PLANNING & ZONING COMMISSION

Wednesday, May 18, 2022, 10:00 AM

- B. **Request for Site Plan; Bristol Park Apartments** (Project Name); 19510 US 4541(Site Address) Limit Ave (South) US Hwy 441 (North East) (Location); Cagan Management Group, Inc. (Applicant); Wicks Engineering Services, Inc. (Engineer); L.R. Huffstetler, Inc. (Landscape Architect); Forum Architecture & Interior Design (Architect). Project No. SP22-03.

BRISTOL PARK APARTMENTS
 COVER SHEET
 MOUNT DORA, FLORIDA 34736

Wicks Engineering Services, Inc.
225 West Main Street, Tallahassee, Florida 32309
www.wicksengineering.com (904) 343-8667
CA #00662

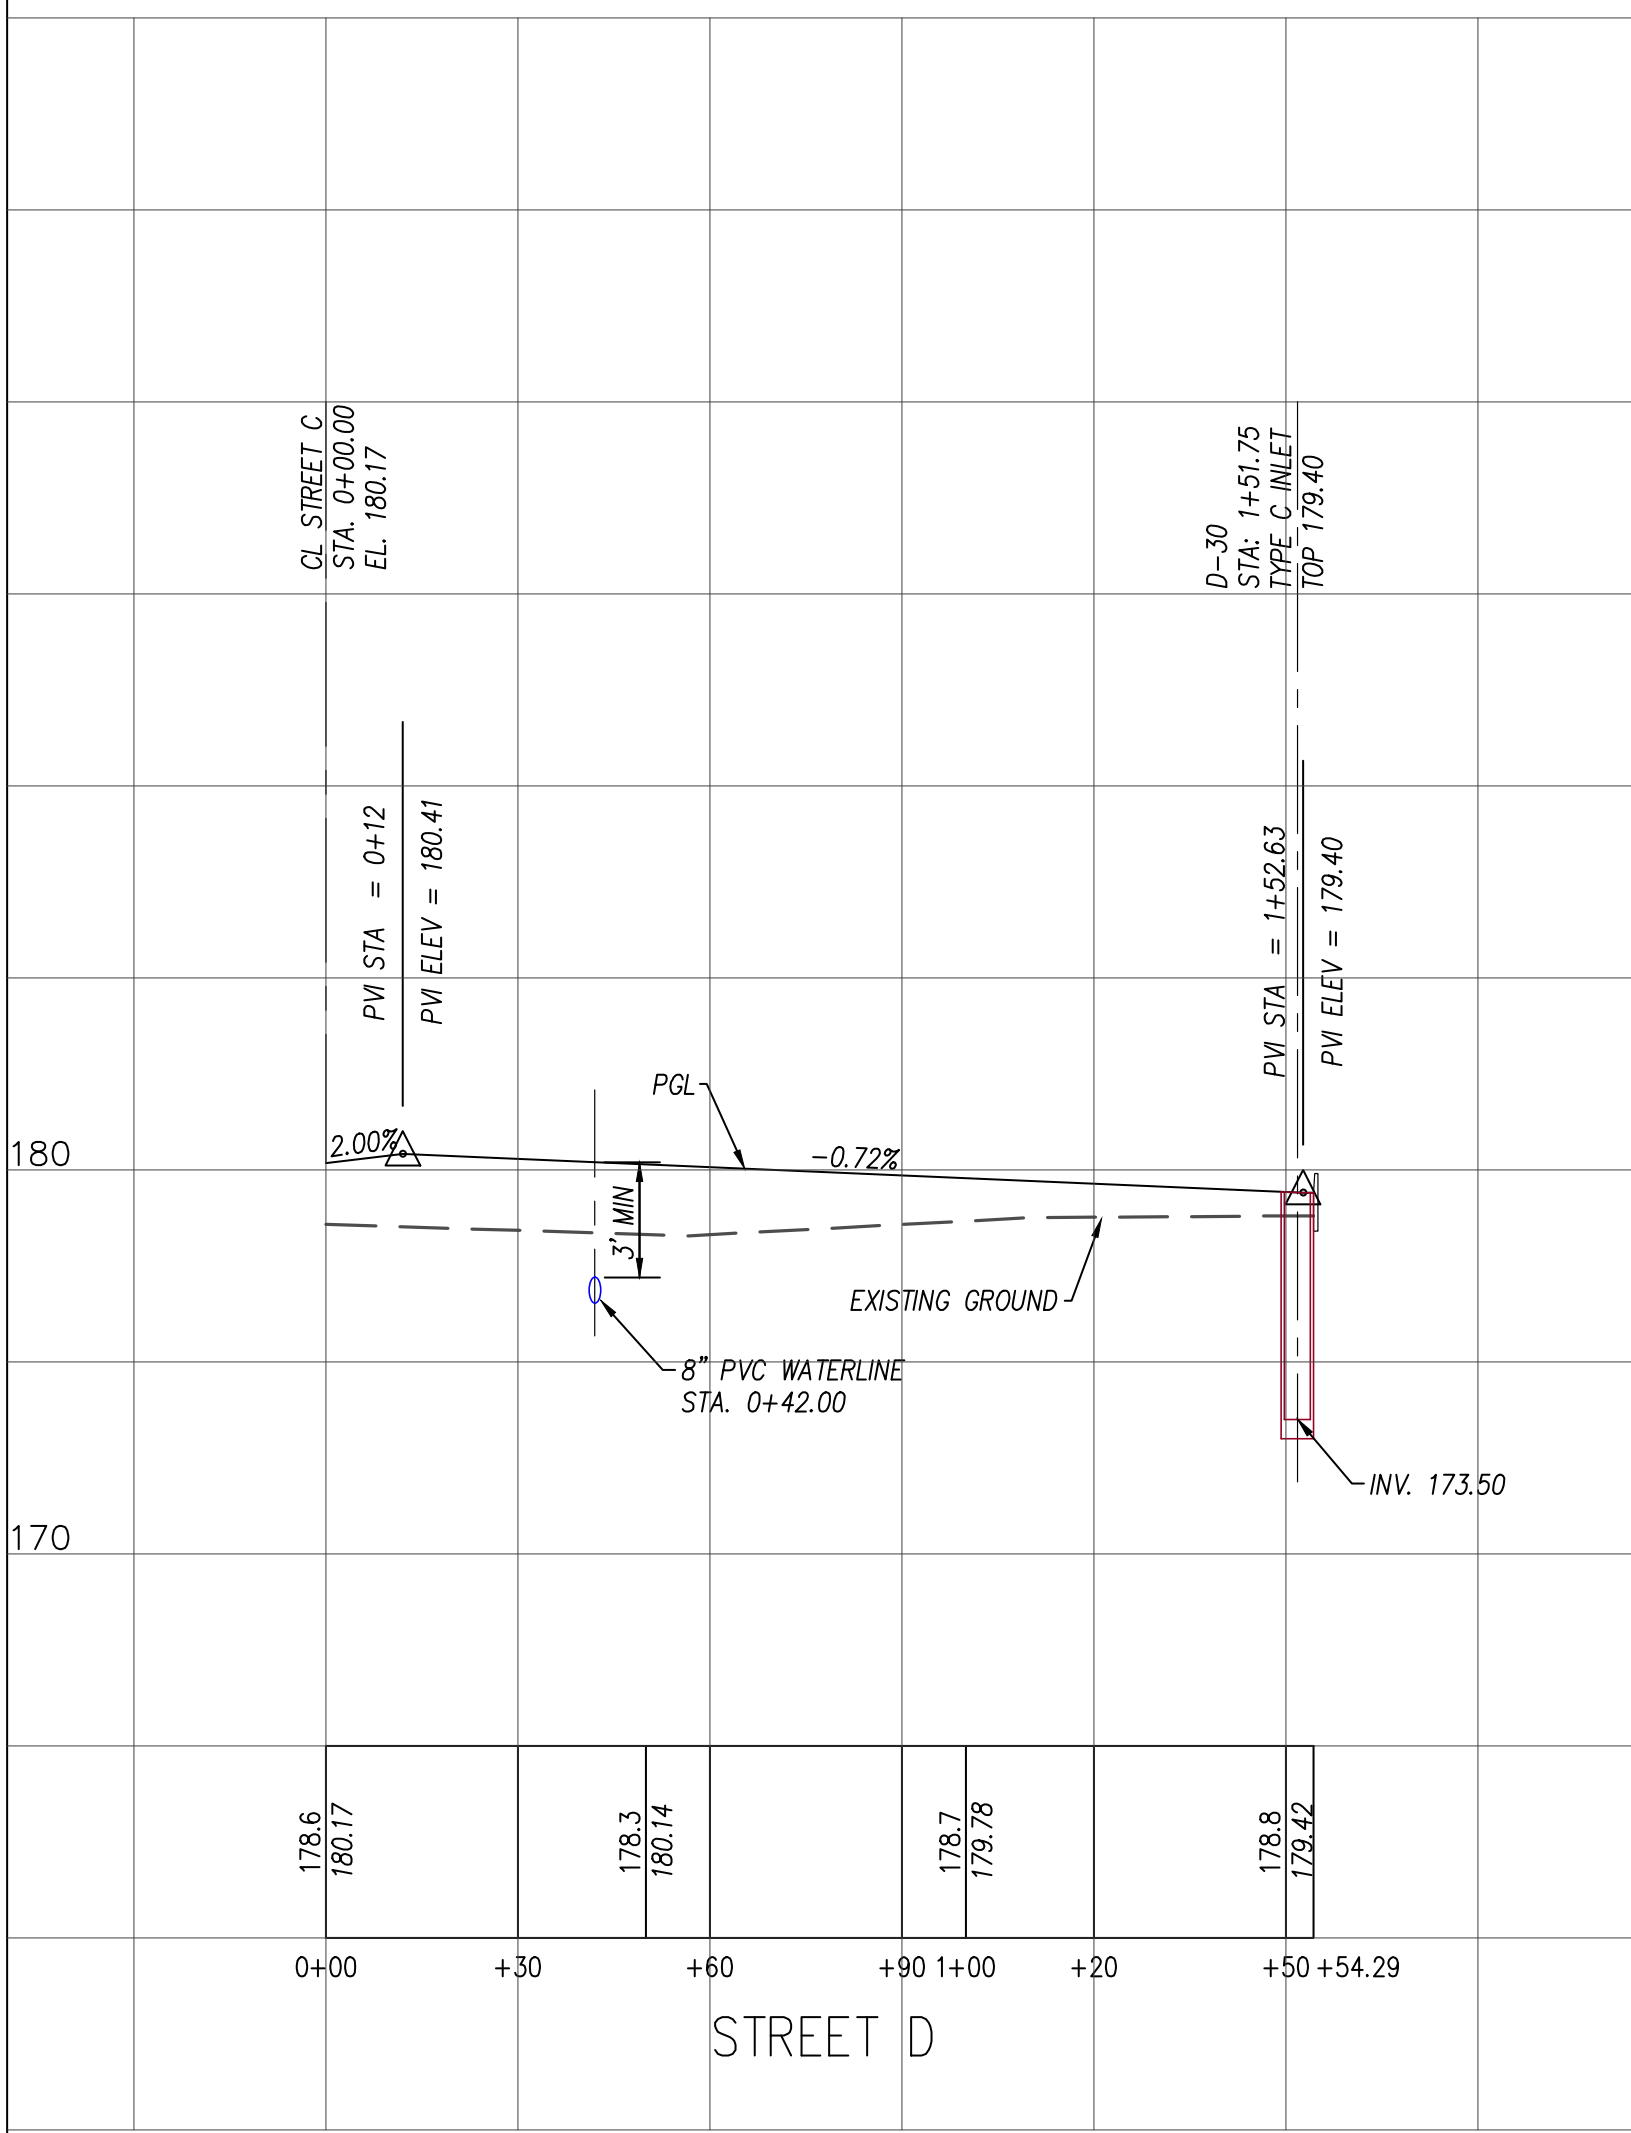
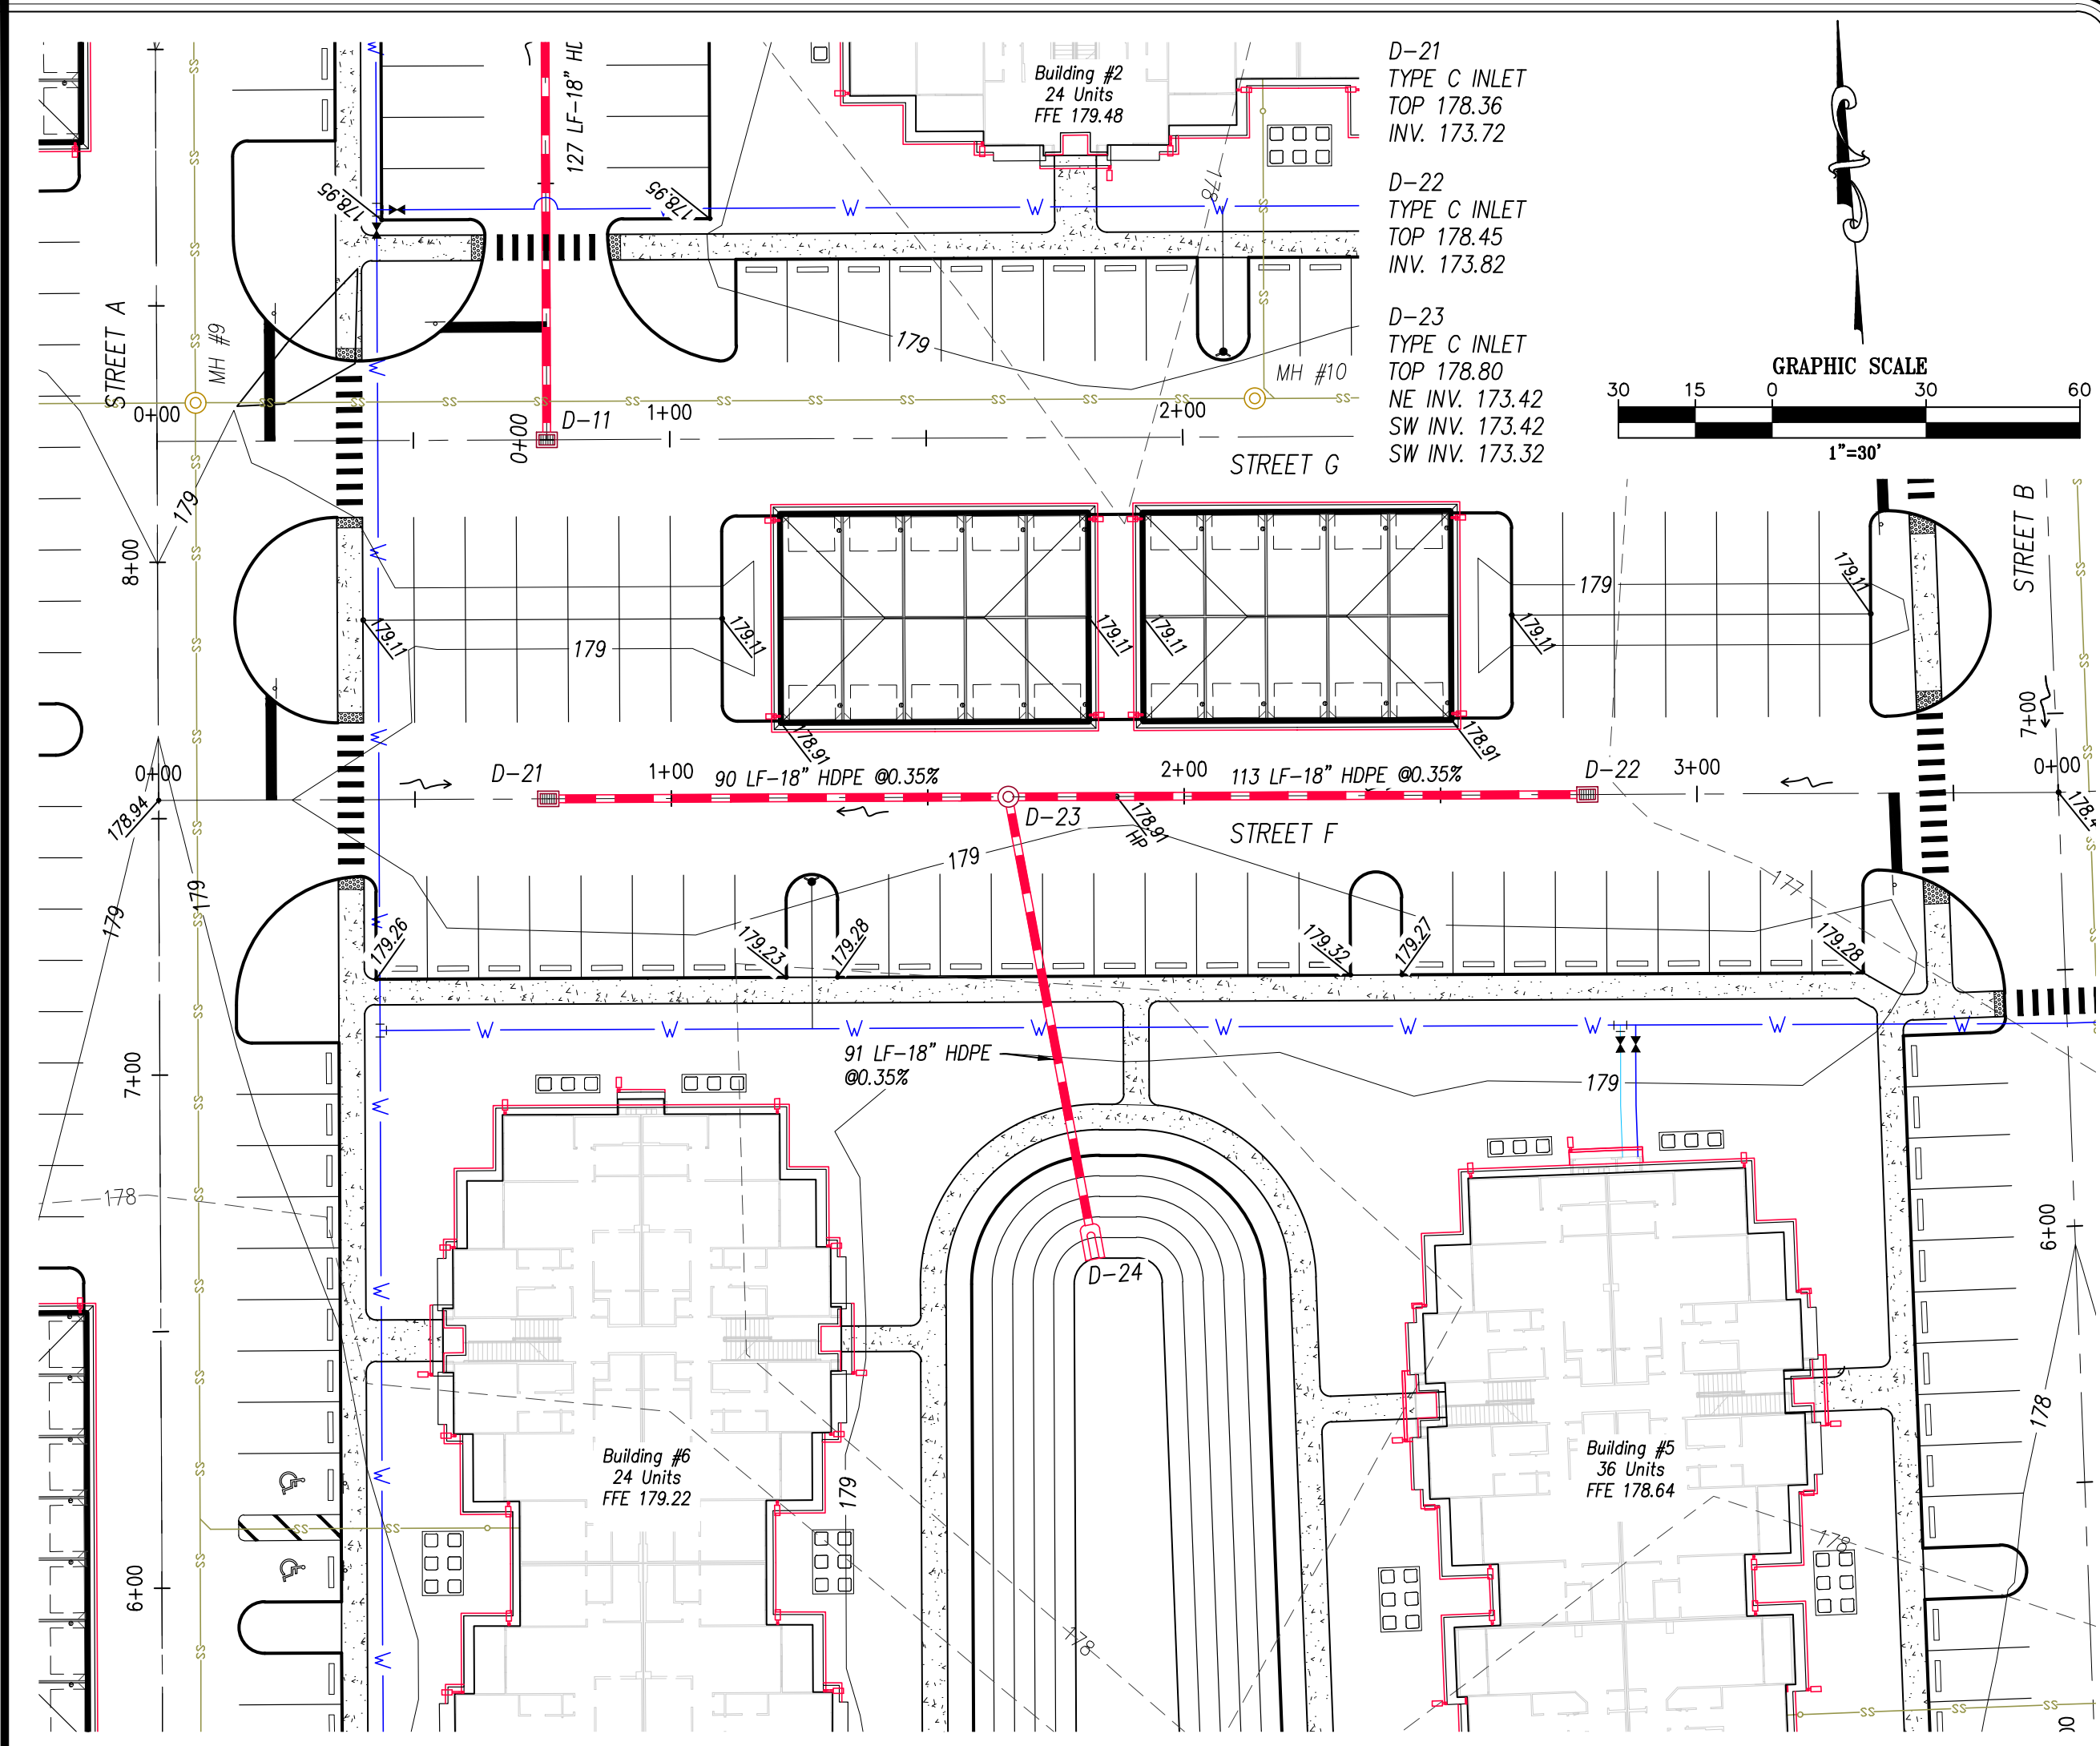
82. Sheet 15 of 32 – in the left hand profile view the water is shown to be at the same elevation as the sanitary sewer. Please correct with appropriate separation distances.
